Access Compliance Report

Public Rights-of-Way

(Curb Ramps)

Intersection ID: 27673	Main Street: GUNPOWDER_POINT_DR	Cross Street: NOLEN_LN	Location: NW
ADA ID: F9D6829DB0CD	Ramp Type: Perp	Initial Pass/Fail: Fail	Overall Compliance: No
Severity Score: 46.25			
Codes/Mitigation Info/Possible Solution		Field Measurements/Component Compliance

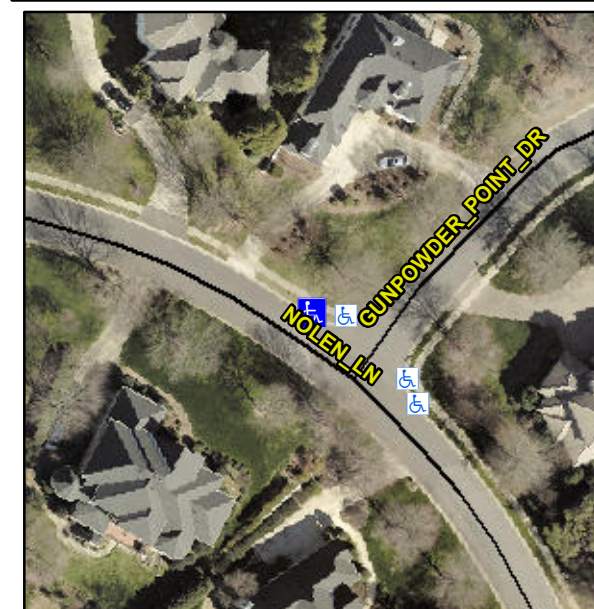
Not Found, R304.5.1, R304.2.2, R304.5.3

Compliance	Description	Data	Compliance	Description	Data
N/A	Ramp Length (in)	50.0	No	Ramp Slope (%)	9.1
No	Ramp Width (in)	44.5	No	Ramp XSlope (%)	9.5
N/A	Flare Type LT	N/A	N/A	Flare Type RT	N/A
N/A	Flare Slope LT (%)	N/A	N/A	Flare Slope RT (%)	N/A
N/A	Flare Traversable LT?	N/A	N/A	Flare Traversable RT?	N/A
N/A	Landing Length (in)	N/A	N/A	DWS Provided?	N/A
N/A	Landing Width (in)	N/A	N/A	DWS Contrast?	N/A
N/A	Landing Slope (%)	N/A	N/A	DWS Length (in)	N/A
N/A	Landing X Slope (%)	N/A	N/A	DWS Full Width?	N/A
N/A	Landing Curb? (Y/N)	N/A	N/A	DWS Offset (in)	N/A
N/A	Shared Landing?	N/A			
N/A	Gutter Ponding?	N/A	N/A	Gutter Slope (%)	N/A
N/A	Gutter Lip Ht (in)	N/A	N/A	Gutter X Slope (%)	N/A
N/A	Painted X Walk1?	No	N/A	Painted X Walk2?	N/A
	X Walk 1 Direction	To SW		X Walk 2 Direction	N/A
N/A	X Walk 1 Width (in)	N/A	N/A	X Walk 2 Width (in)	N/A
	X Walk 1 Slope (%)	2.2		X Walk 2 Slope (%)	N/A
	X Walk 1 X Slope (%)	6.6		X Walk 2 X Slope (%)	N/A

Remove & Replace Entire Ramp.
